# Access Compliance Report

### (Curb Ramps)

Intersection ID: 11879	Main Street: AIRLIE_ST	Cross Street: ELLEN_AV	Location: SW
ADA ID: 45096079461C	Ramp Type: Perp	Initial Pass/Fail: Fail	Overall Compliance: No
Severity Score: 21.25			
Codes/Mitigation Info/Possible Solution		Field Measurements/Component Compliance

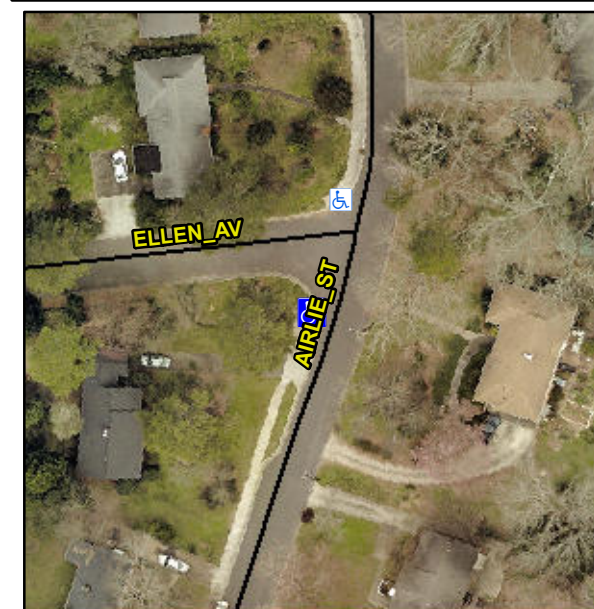
**Not Found, R304.5.1, R304.5.3**

Compliance	Description	Data	Compliance	Description	Data
N/A	Ramp Length (in)	73.0	Yes	Ramp Slope (%)	5.1
No	Ramp Width (in)	43.0	No	Ramp XSlope (%)	5.4
N/A	Flare Type LT	N/A	N/A	Flare Type RT	N/A
N/A	Flare Slope LT (%)	N/A	N/A	Flare Slope RT (%)	N/A
N/A	Flare Traversable LT?	N/A	N/A	Flare Traversable RT?	N/A
N/A	Landing Length (in)	N/A	N/A	DWS Provided?	N/A
N/A	Landing Width (in)	N/A	N/A	DWS Contrast?	N/A
N/A	Landing Slope (%)	N/A	N/A	DWS Length (in)	N/A
N/A	Landing X Slope (%)	N/A	N/A	DWS Full Width?	N/A
N/A	Landing Curb? (Y/N)	N/A	N/A	DWS Offset (in)	N/A
N/A	Shared Landing?	N/A			
N/A	Gutter Ponding?	N/A	N/A	Gutter Slope (%)	N/A
N/A	Gutter Lip Ht (in)	N/A	N/A	Gutter X Slope (%)	N/A
N/A	Painted X Walk1?	No	N/A	Painted X Walk2?	N/A
	X Walk 1 Direction	To N		X Walk 2 Direction	N/A
N/A	X Walk 1 Width (in)	N/A	N/A	X Walk 2 Width (in)	N/A
	X Walk 1 Slope (%)	6.4		X Walk 2 Slope (%)	N/A
	X Walk 1 X Slope (%)	0.2		X Walk 2 X Slope (%)	N/A

**Remove & Replace Entire Ramp.**
